Re: Niagara Mohawk Power Corporation
Nine Mile Point Nuclear Station,
Unit No. 1
Docket No. 50-220

APPLICATION FOR AMENDMENT

Proposed Changes To The Technical Specifications (Appendix A)

Replace Pages 8, 20, 64a, 64b, 64c, 70a, 70b, and 70c with the attached revised pages. Remove Pages 64d, 64e and 64f.

Figure 2.1.1. Flow Biased Scram and APRM Rod Block

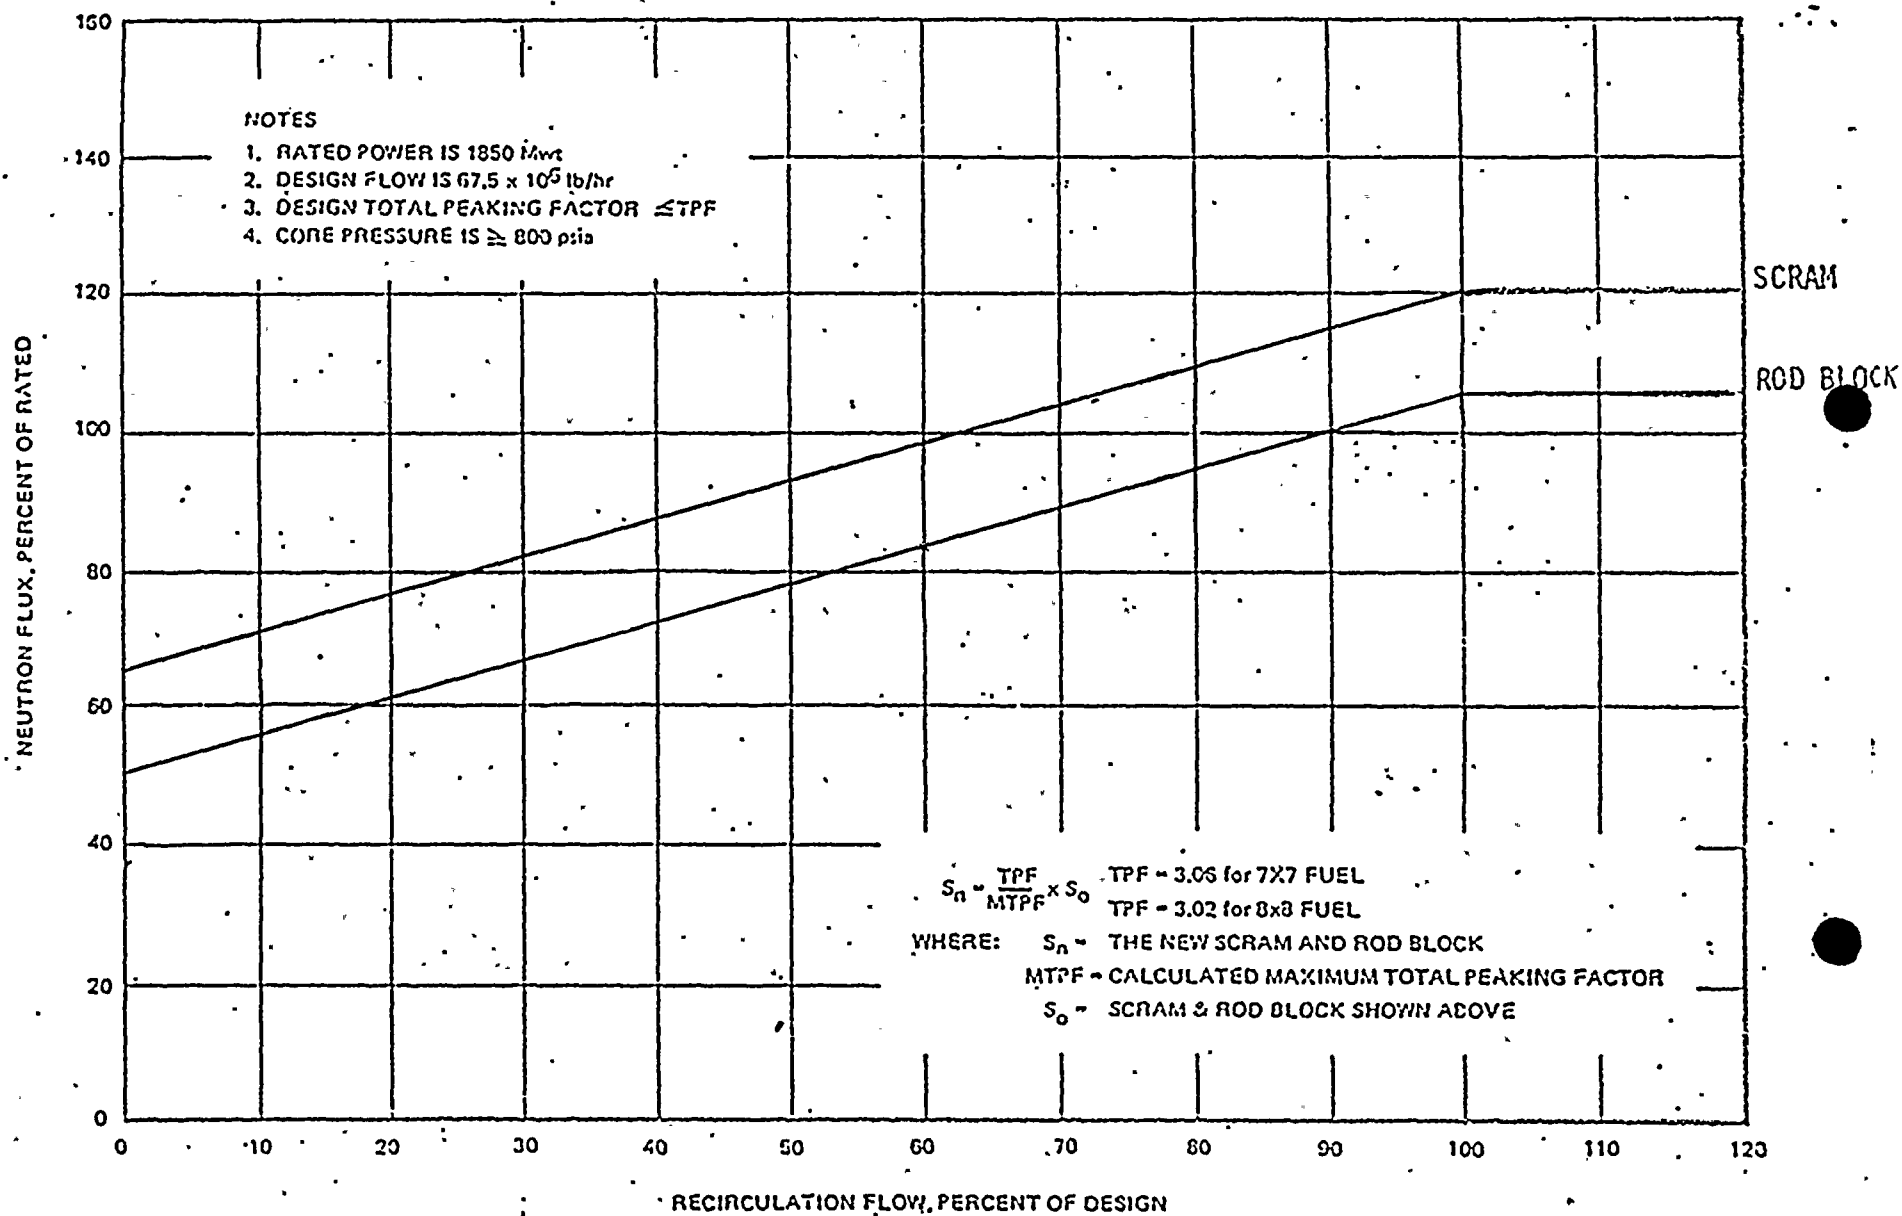
To take advantage of as much of the analyzed envelope as possible, a change is required in the APRM flow biased rod block line and the 120 percent flow biased flux scram line. The current APRM rod block and flux scram lines are overly conservative at low power/low flow conditions. The new rod block and scram lines maintain previously established safety limits.

Figure 3.1.7.f
NINE MILE POINT UNIT 1
LIMITING POWER FLOW LINE

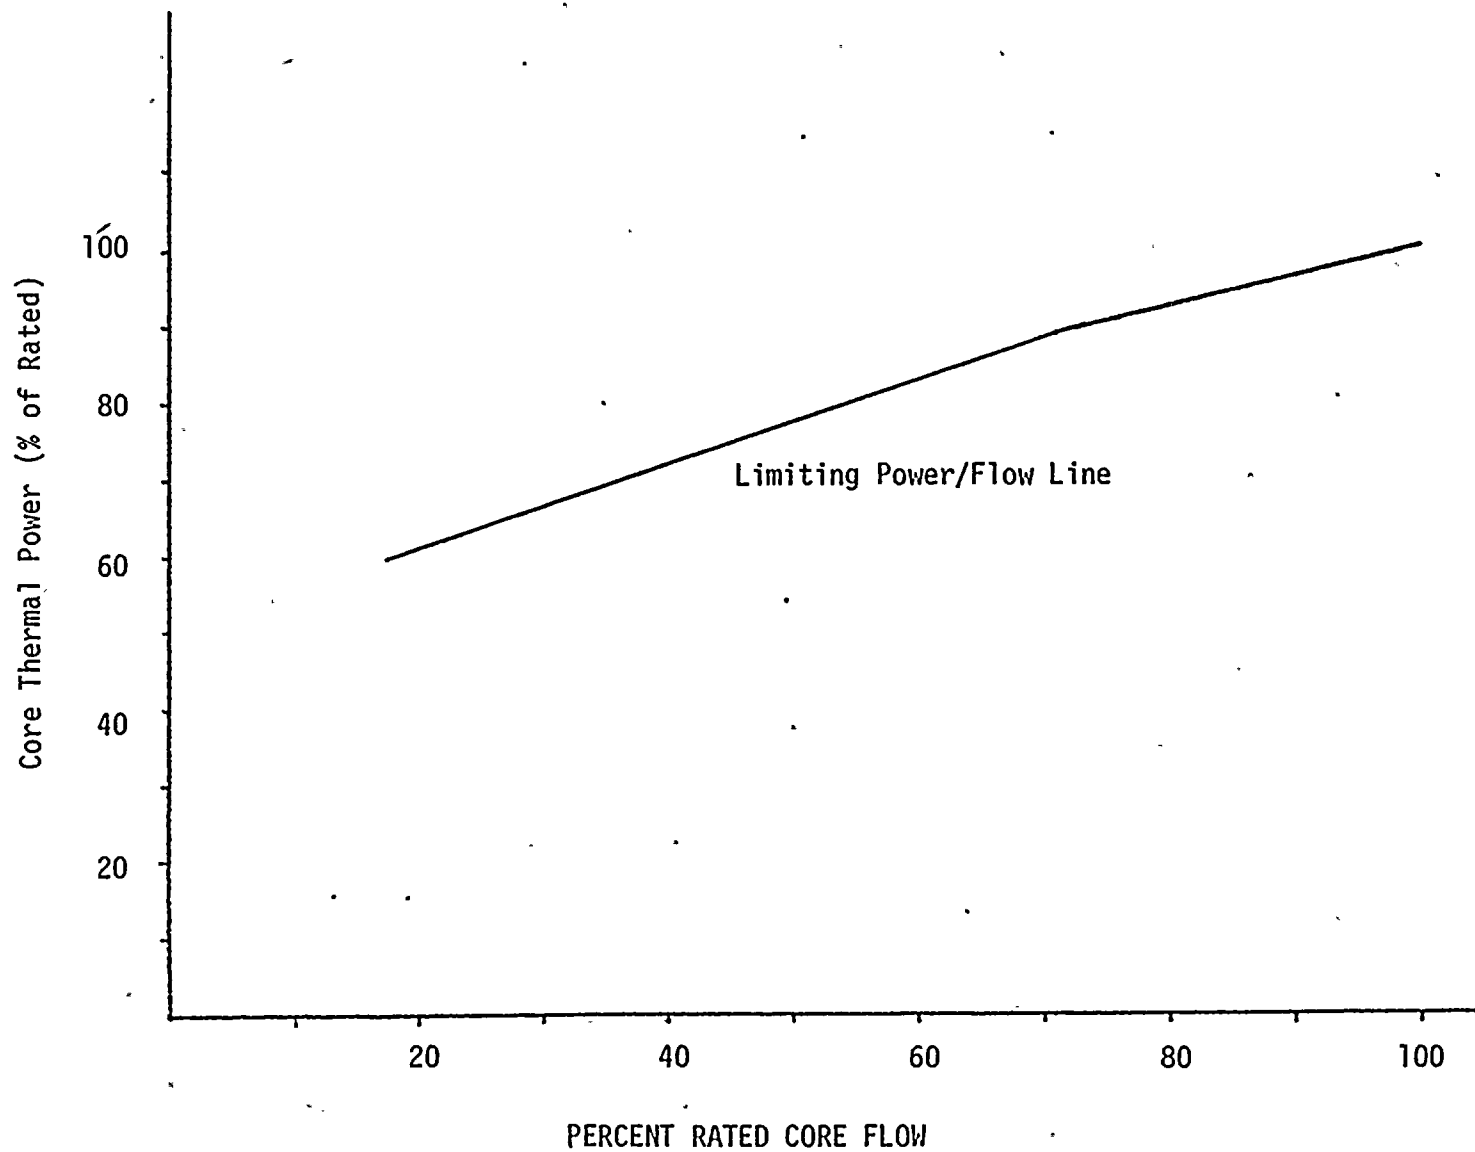
The power/flow relationship shall not exceed the limiting values shown in Figure 3.1.7.f.

Each transient and accident was analyzed along the new power/flow line. The results show that the 100/100 percent power/flow point is the most limiting for all accidents and transients except for the Rod Withdrawal Error. Results of the Rod Withdrawal Error analysis show a slightly higher (+0.01) Δ CPR at the 91/75 percent power/flow point for 7 x 7 fuel. The analysis also indicates that the new power/flow envelope maintains previously established safety limits.
